AGENDA ITEM REPORT

ITEM: Review and discussion of Site Plan Application by 9201 West LLC to construct a 6 unit, 3- Story Multi-Family Development to be located at 9201 West Bay Harbor Drive. Enclosed are the Site Plans and the Staff Report prepared by Town Planner Michael Miller.

Subject: **Site Development Plan Application**
 Bay Harbor III Townhouses -5 DU Townhouse Complex
 9201 - 9241 West Bay Harbor Drive
 Bay Harbor Islands Acct. No. SPR22-00002
 MMPA Account No. 01-0702-1114

MMPA recommends the Development Review Committee (DRC) **DEFER** action on the proposed Site Development Plan application at this time to allow the applicant's design team to address the listed comments. The submittal package has several design / Code violation issues, some of the plans are inadequate or missing and a few other items need to be corrected.

Five Townhomes for:
BAY HARBOR III
9201-9241 W. BAY HARBOR DRIVE
BAY HARBOR ISLANDS FL. 33154
ROOF PLAN

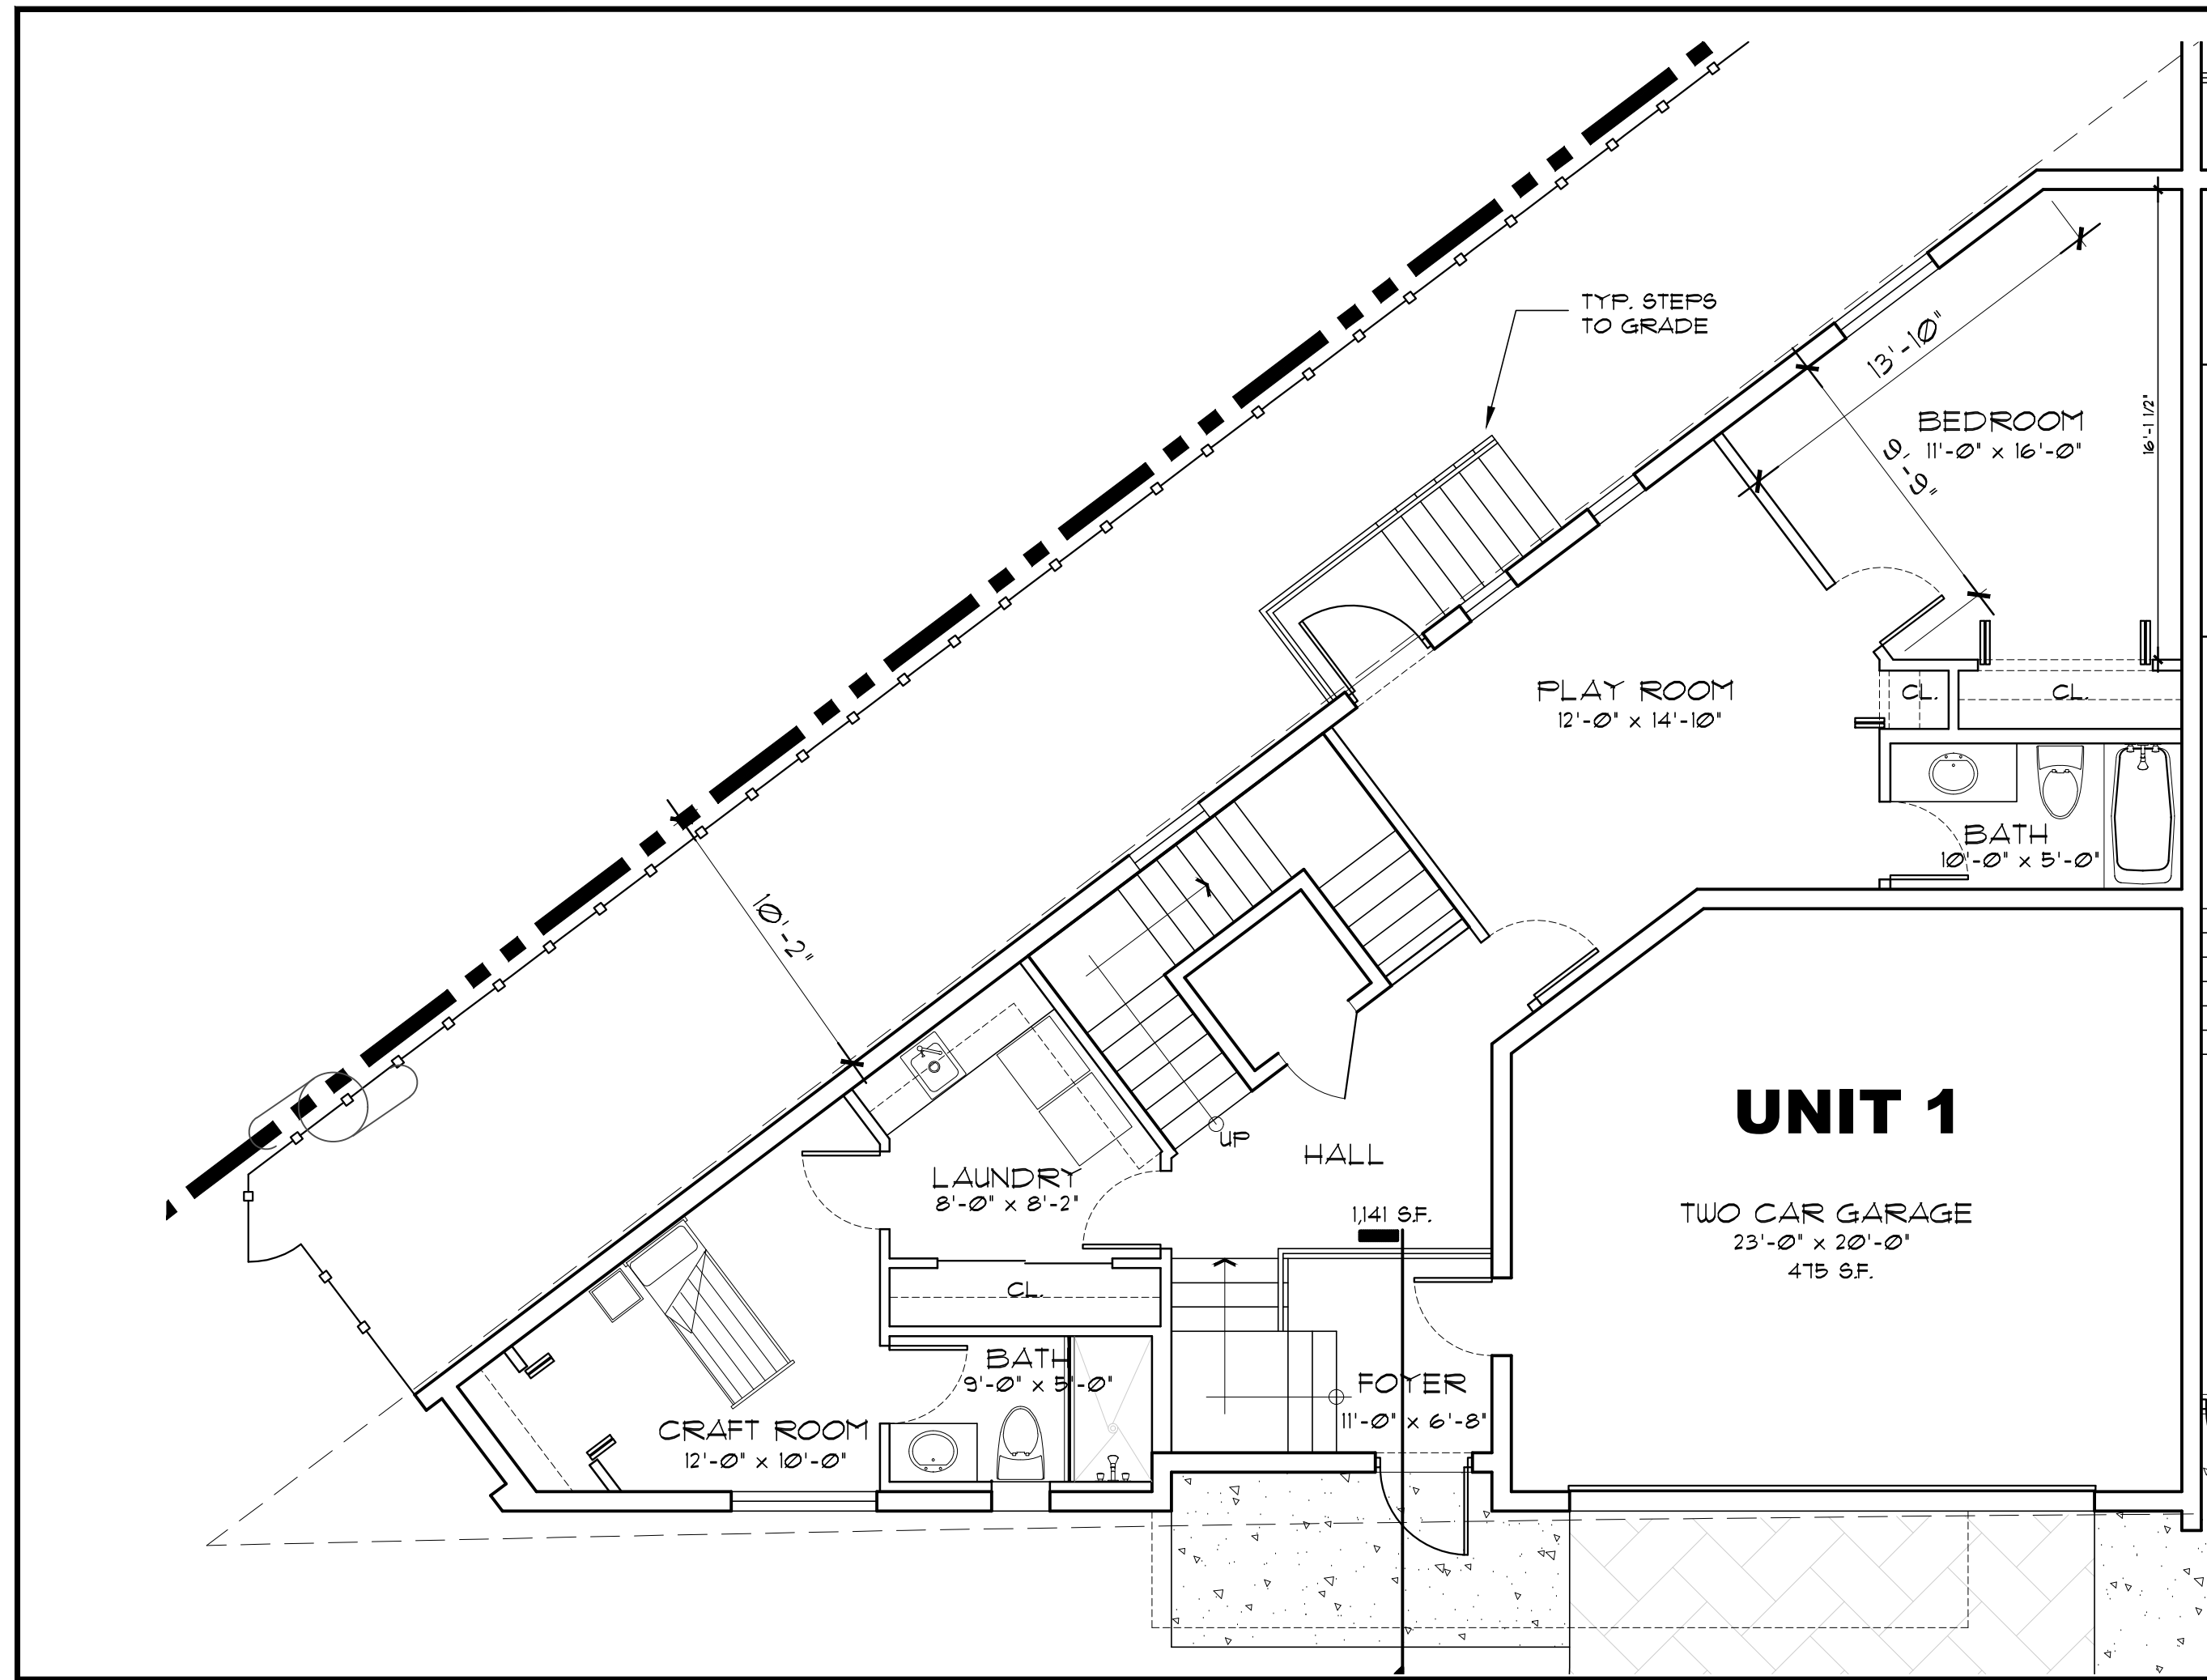
8. On Sheet A-4 Roof Plan large portions of the rooftop are proposed for sundecks. If any portion of a rooftop is used for "recreation" at least 15% of the rooftop area used for recreation must be landscape. Need more detail on what is desired and calculations.
